**BID TITLE: SANTA ROSA PARK IMPROVEMENTS CONSTRUCTION PHASE II**

## **ADDENDUM NO. 2**

#### **III. ETHOS ENGINEERING ADDENDUM #2 – 15 PAGES**

**ADDENDUM NO. 2**

**EP1.1**

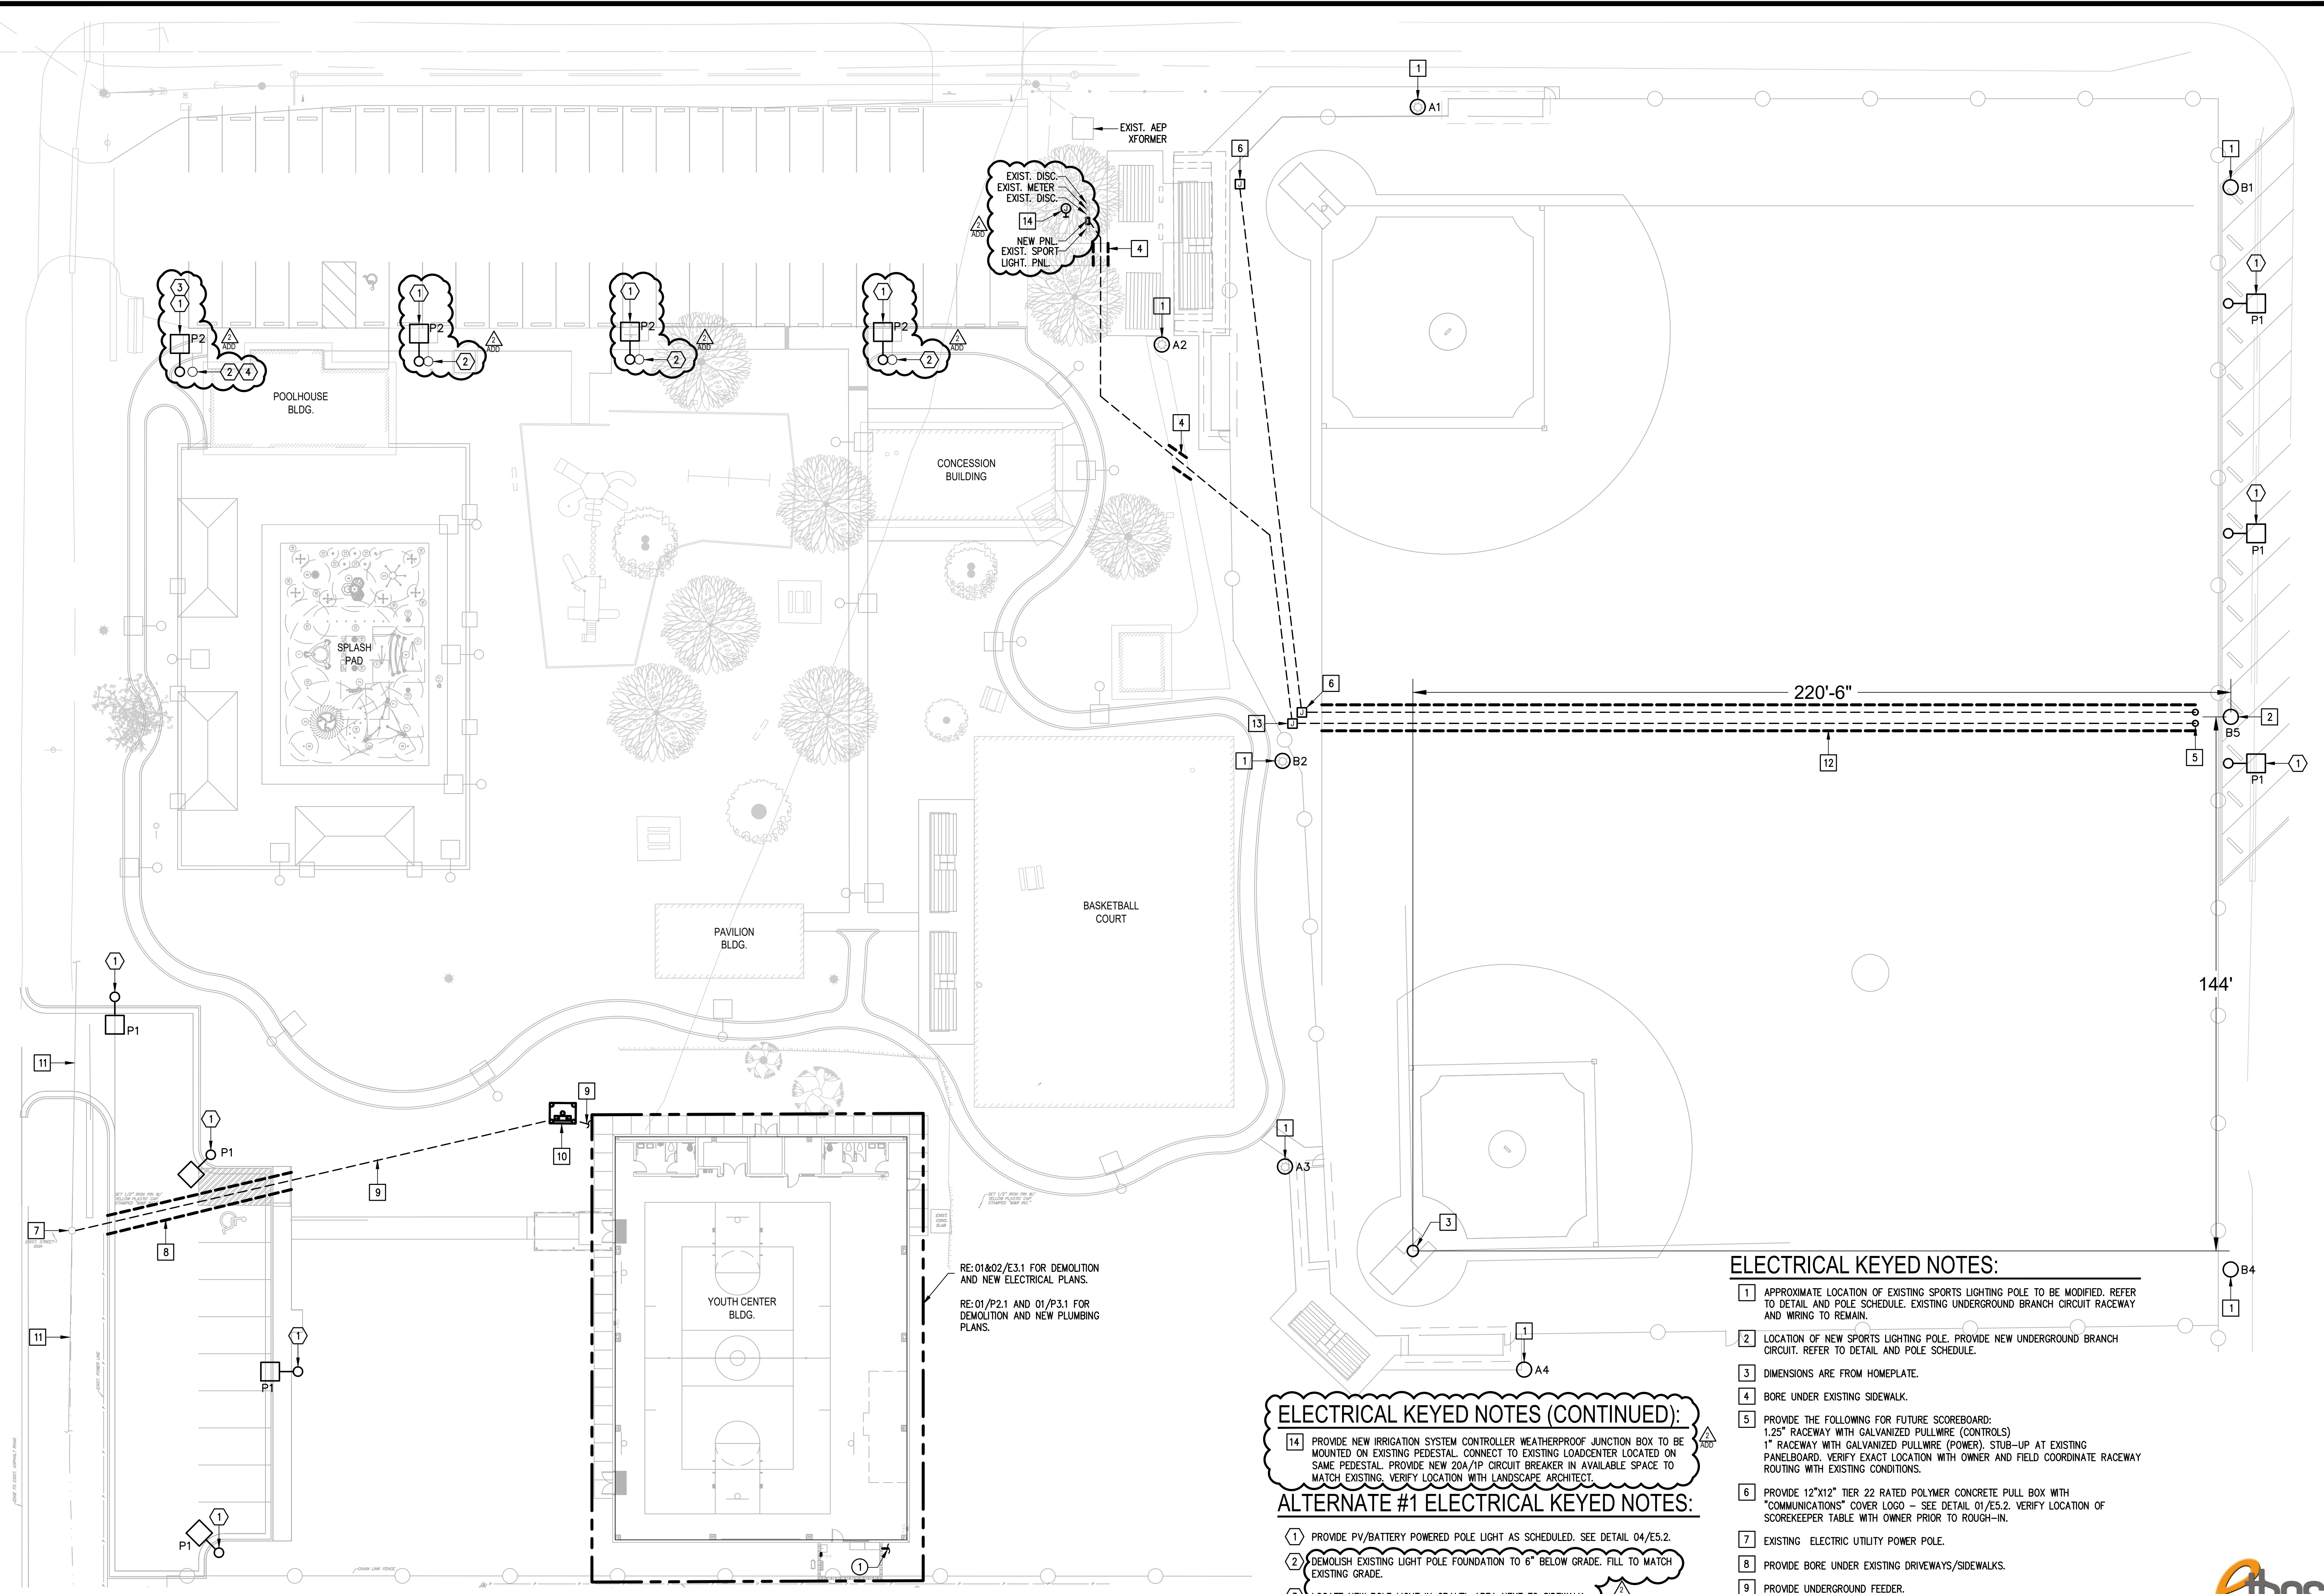
1. Sheet EP1.1: Revised Electrical and Plumbing Site Plan. See attached.
2. Sheet E2.1: Revised Luminaire Schedule, Symbol Legend, and Images. See attached.
3. Sheet E3.1: Revised Gymnasium Lighting and Electrical Plan. See attached.
4. Sheet E4.2: Revised Electrical Panel Schedules. See attached.
